DESCRIPTION OF DIFFERENCES

between ORIGINAL and SIMILARITY

Name of Appliance : 1.9GHz Cordless Telephone System
 SIMILARITY Model No. : KX-TGF350 (Base Unit)
 FCC ID: ACJ96NKX-TGF350
 ORIGINAL Model No. : KX-TGF380 (Base Unit)
 Approval Date : under application
 FCC ID: ACJ96NKX-TGF380

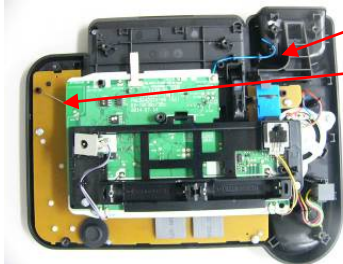
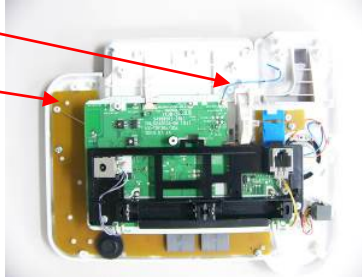
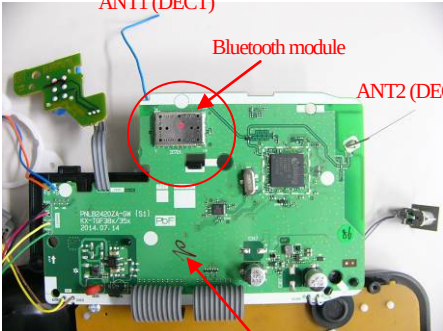
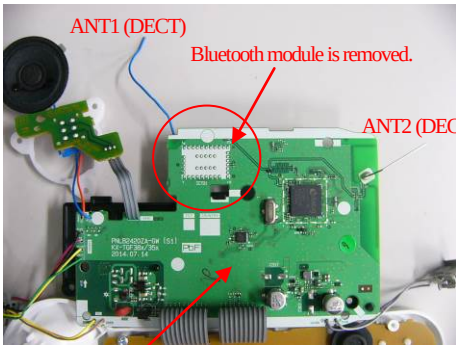
BASIC MODEL KX-TGF380	SIMILAR MODEL KX-TGF350
Appearance		 <i>Not provided with Bluetooth function</i>
Inside Structure	  <i>The BT Antenna are formed in the P.C. board.</i> <i>Inside Structure are identical.</i>	
P.C. Board		 <i>Bluetooth module is removed.</i>
AC adaptor	<i>Both model are used to PNLV226 AC adaptor.</i>
